**From:** Jill Bastow  
**Sent:** 02 August 2016 15:22  
**To:** Planning  
**Subject:** FW: Ocean View, Robin Hoods Bay  
**Attachments:** fwdlumenconservationrooflight.zip

**Condition 5: Repointing of Chimney Stacks**

**Condition 8: Rooflight Details**

Title. **Pantile Jamb Detail Warm Roof Construction**

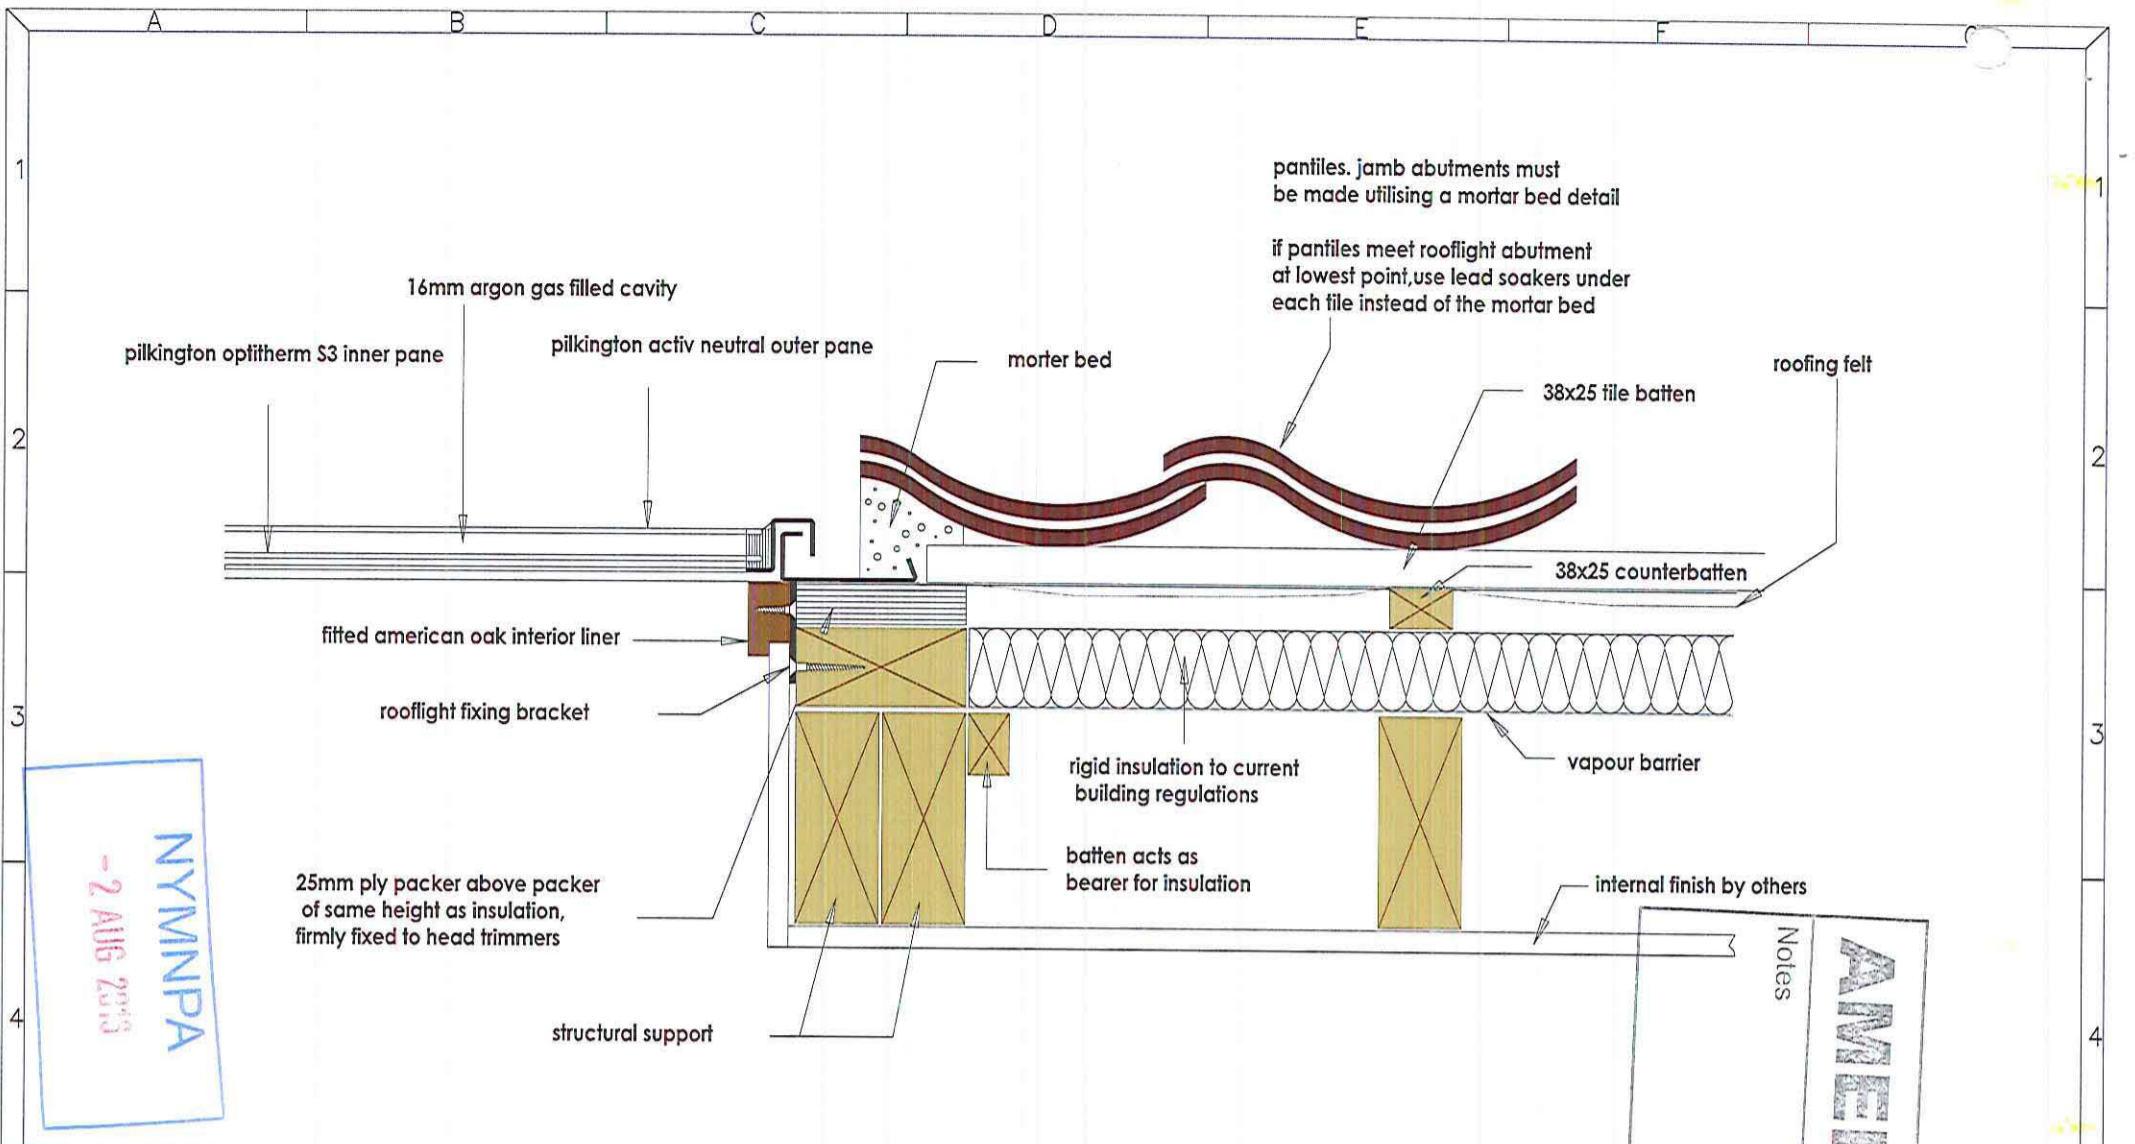
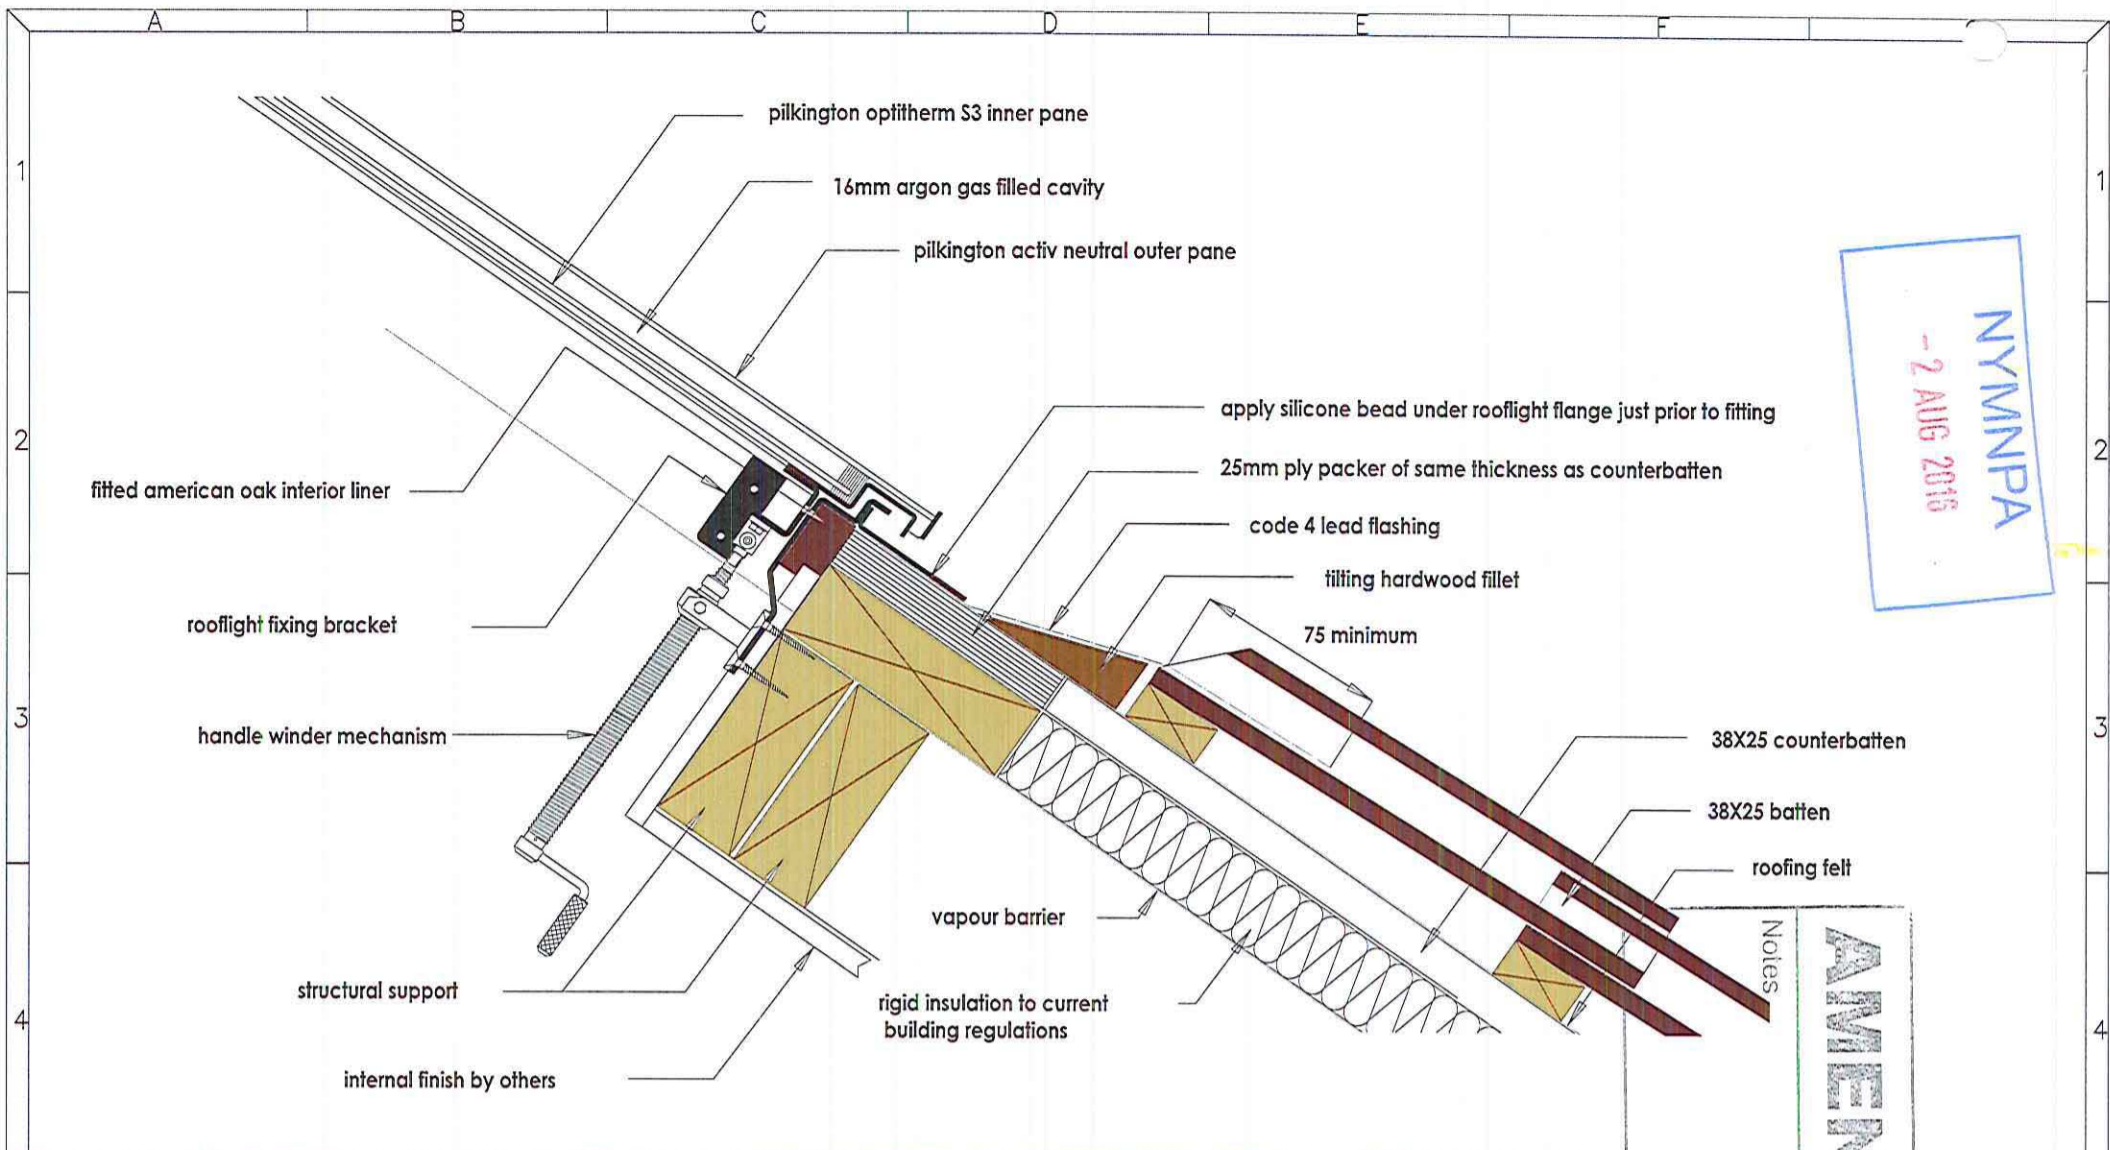
Further to your email below and our recent conversations, please find attached a copy of the revised details for the proposed new rooflight to the Kitchen roof at Ocean View in Robin Hood's Bay. In addition, the rooflight will be a non-openable unit with a central glazing bar, as per the attached drawings.

Please can you confirm which rooflight (make, model and size) is proposed in due course.

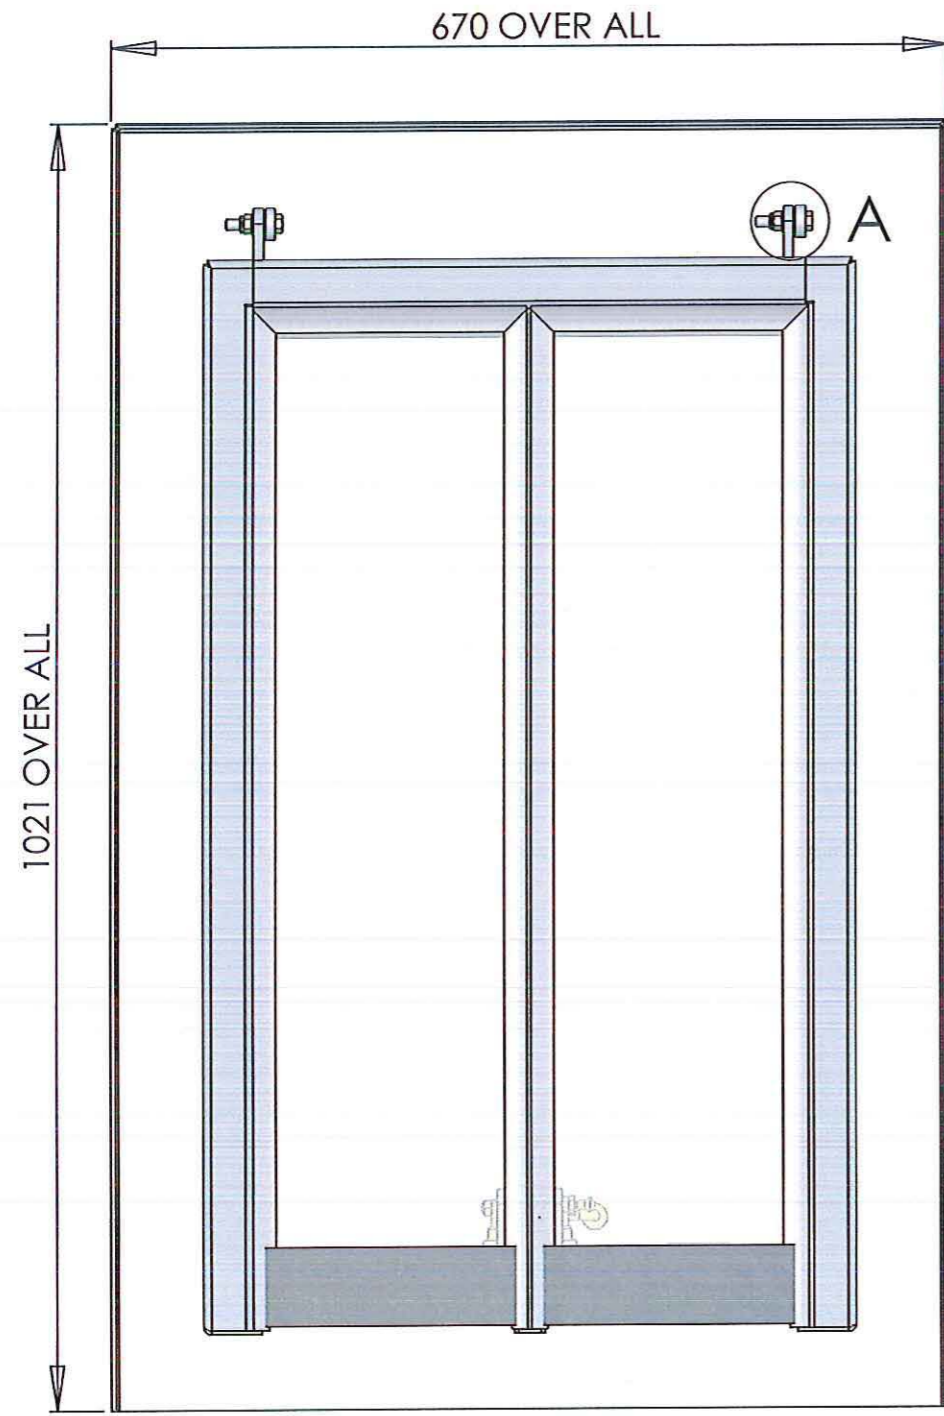
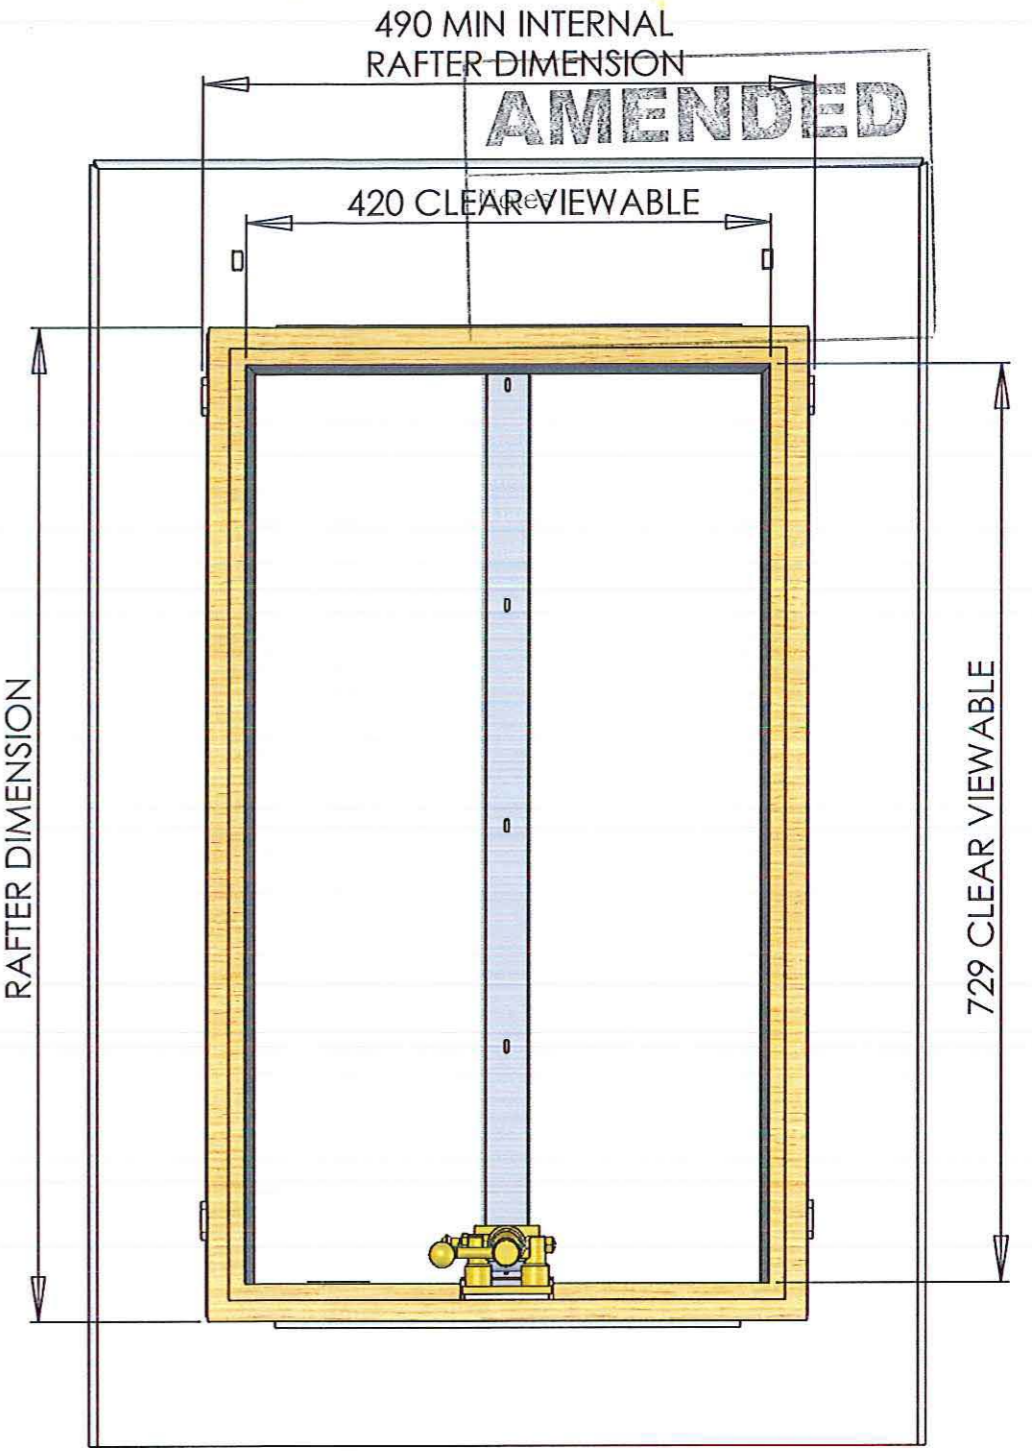
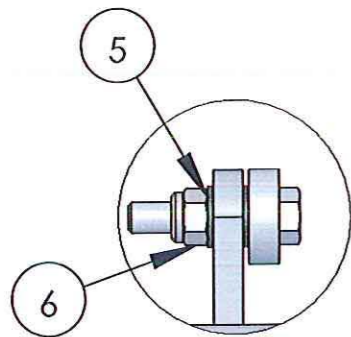
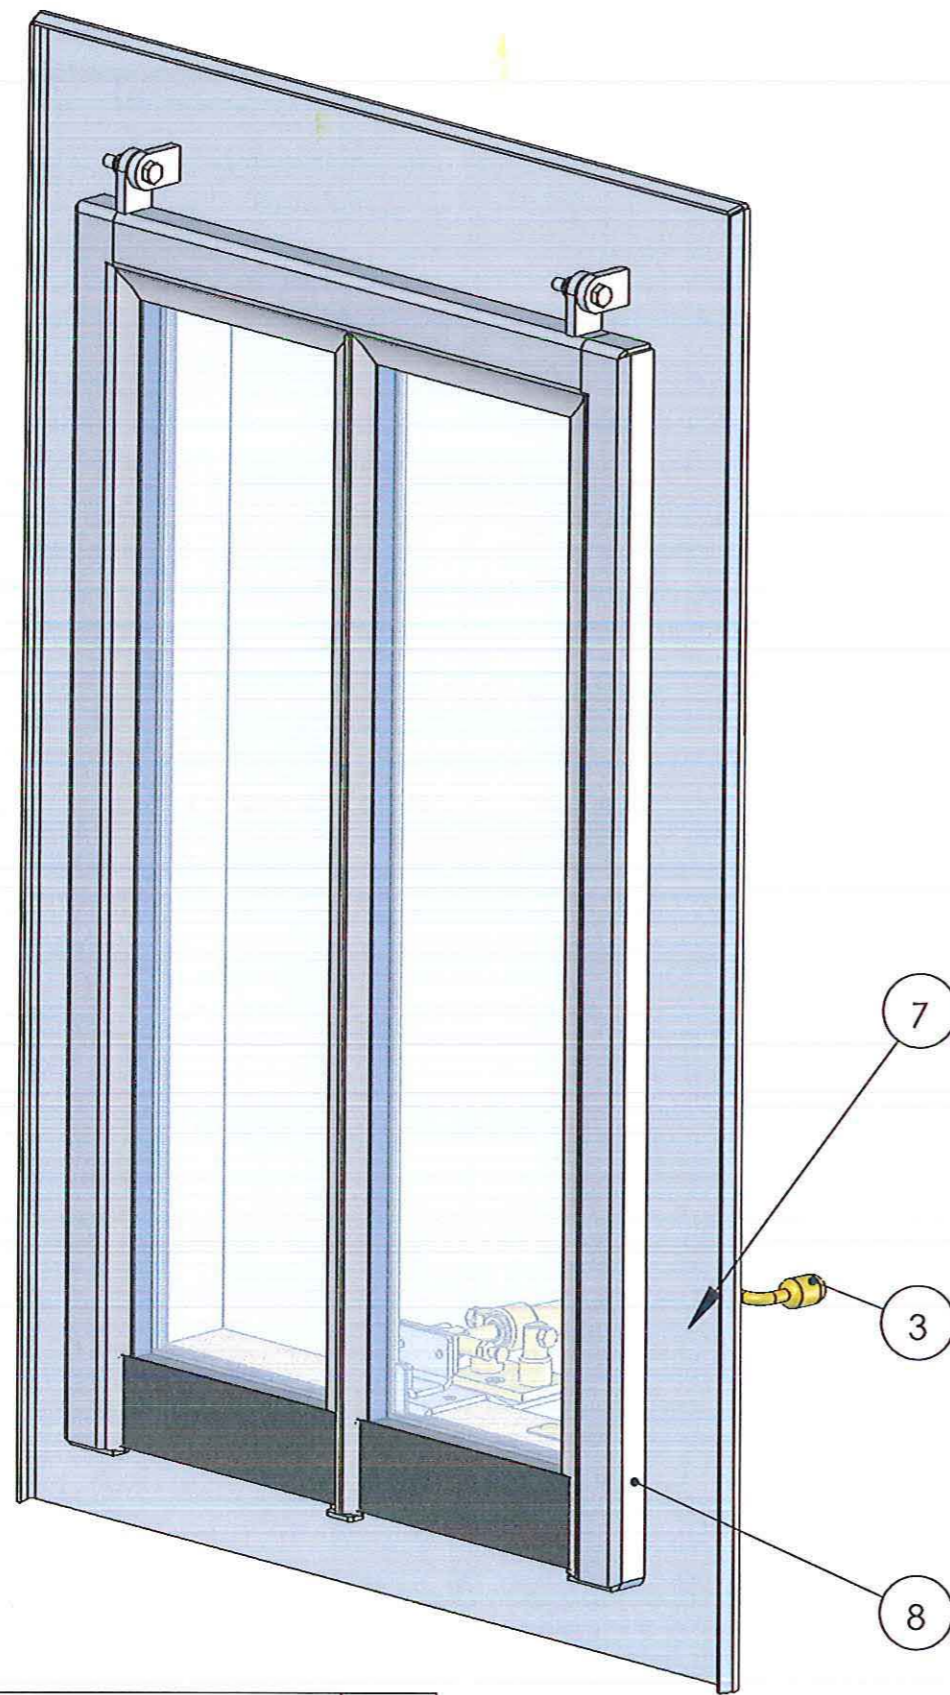
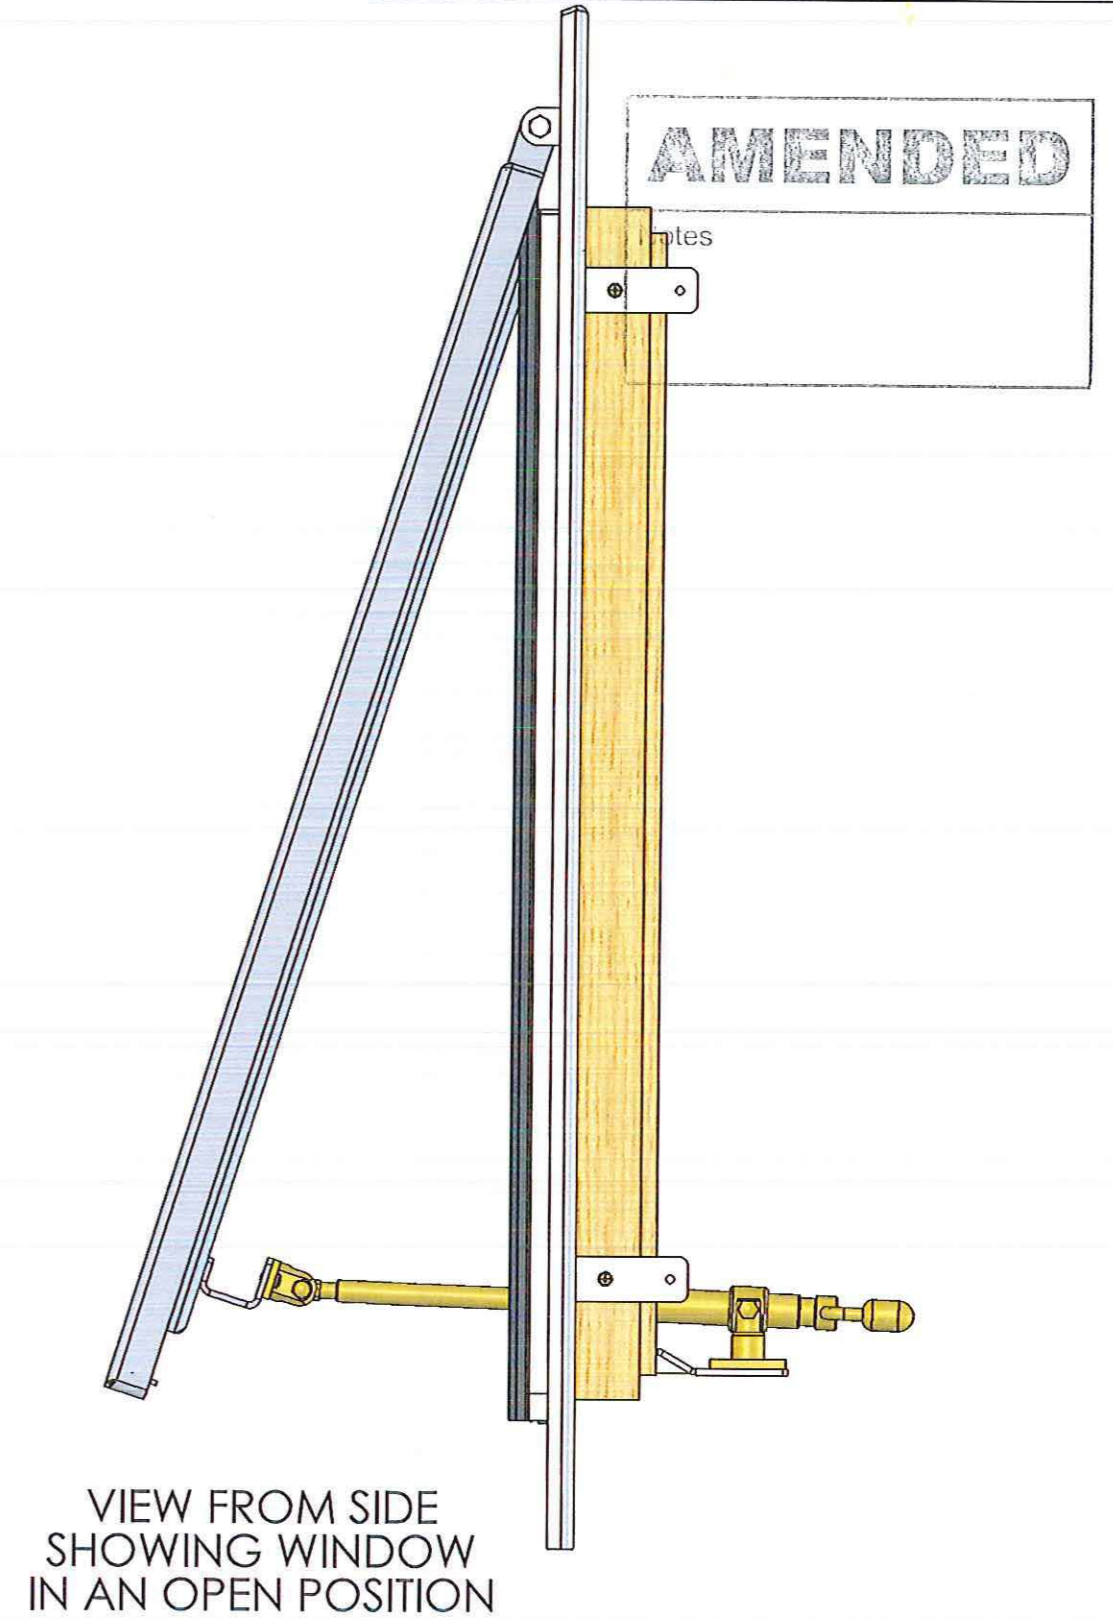
The applicant agrees to the provision of a metal framed, top-hung fixture for installation within the roof above the Kitchen, as requested – to be sourced from either Lumen Roof Windows or The Rooflight Company. **Please confirm whether further details of the proposed unit are required to be submitted.**

*Please provide details.*
